SEWAGE DISPOSAL SYSTEM

MARYLAND STATE DEPARTMENT OF HEALTH

A SEWAGE DISPOSAL-SYSTEM LOCATED AT

130 N. Rogers Ave

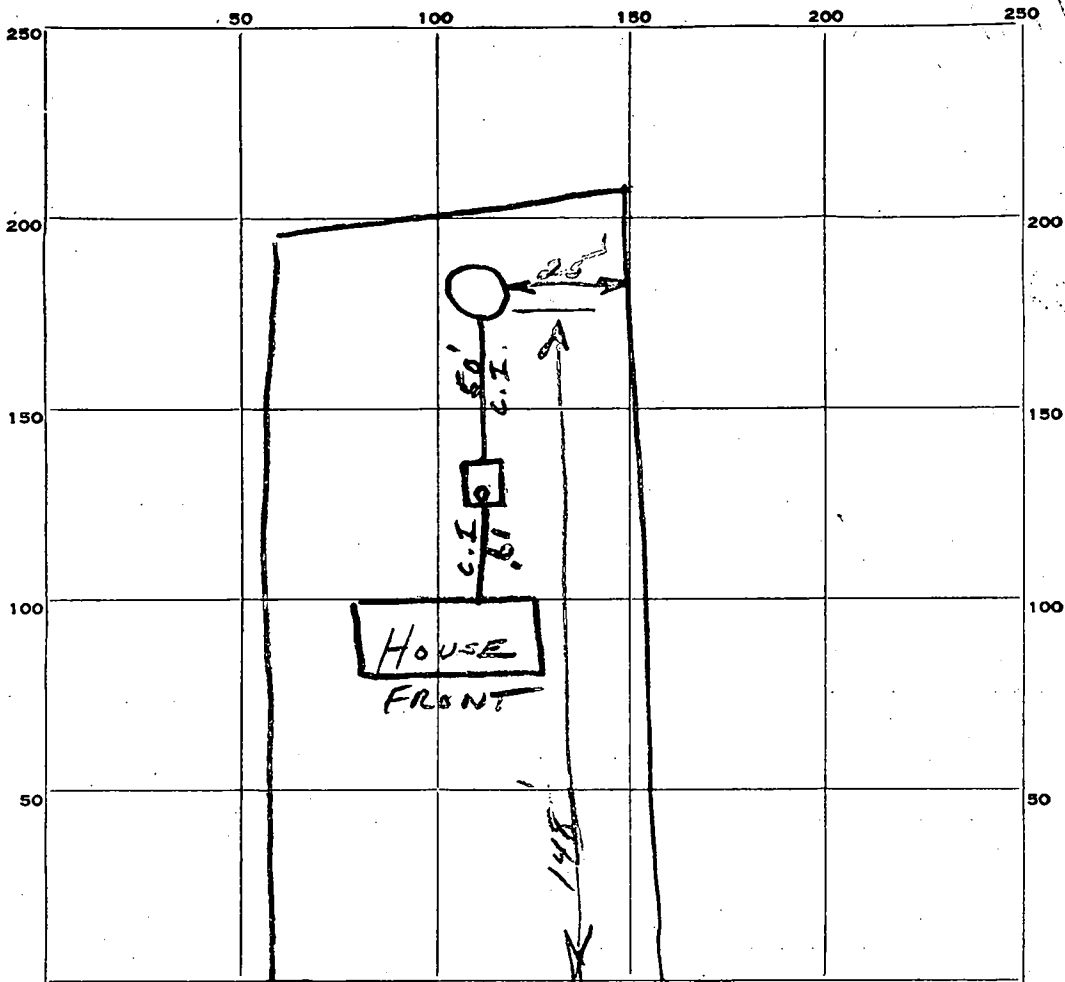
Permission given to locate dry well about 115 ft from front line instead of 120 ft because of clearance of original lot to the well on the property to the right side of original lot. a Dry Well 12 ft diameter and 9 ft deep below the inlet pipe is to be installed. 9/14/62

Locate the dry well ^{about 115} 20 ft. from the front property line and 24 ft. from the left side property line. Left side property line determined when facing the lot from N. Rogers Ave. Above refers to the original ground.
